Docket Number: 52-045

Subject: **Request for Additional Information Letter Number 8 Related to Chapter 6 for GE-Hitachi Nuclear Energy Advanced Boiling-Water Reactor Design Certification Rule Renewal Application- GEH Response to RAI 06.03-2, Revision 2**

GEH Revised Response to RAI 06.03-2

Figure 5.4-9 Reactor Core Isolation Cooling System PFD (Sheet 1 of 2)

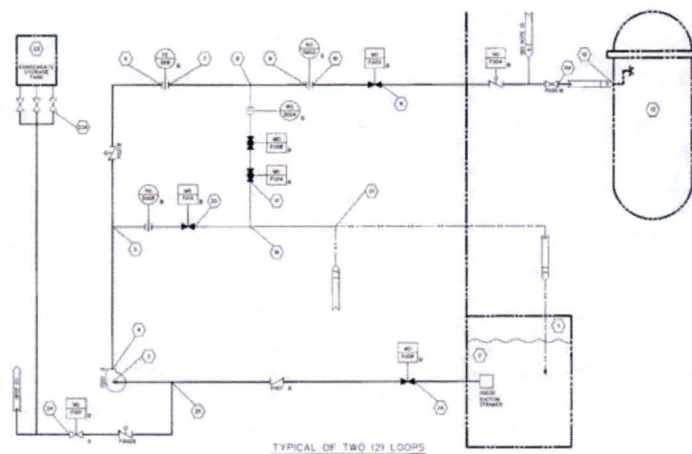
- Figure 1.2-13i Updated wetwell arrangement plan to reflect GE stacked disk strainer design that supersedes the T-type conical strainer design (Chapter 21, Volume 1; contains security-related information)
- Figure 5.4-9 (Sh. 1 of 2) Note 10- Replaced requirement for 50% blockage of RCIC suction strainer with strainer head loss at design value
- Figure 5.4-11 (Sh. 2 of 2) Numerous entries- Replaced requirement for 50% blockage of RHR suction strainer with strainer head loss at design value

REPLACE WITH THE FOLLOWING:

10. FLOW VALUES SHOWN IN MODES C & D ARE BASED UPON SUCTION PIPING DESIGN PERMITTING THE MINIMUM REQUIRED NPSH TO CONTINUE TO BE PROVIDED TO THE RCIC PUMP WHEN SUPPRESSION POOL SUCTION STRAINER IS 50 PERCENT PLUGGED HEAD LOSS IS AT THE DESIGN VALUE
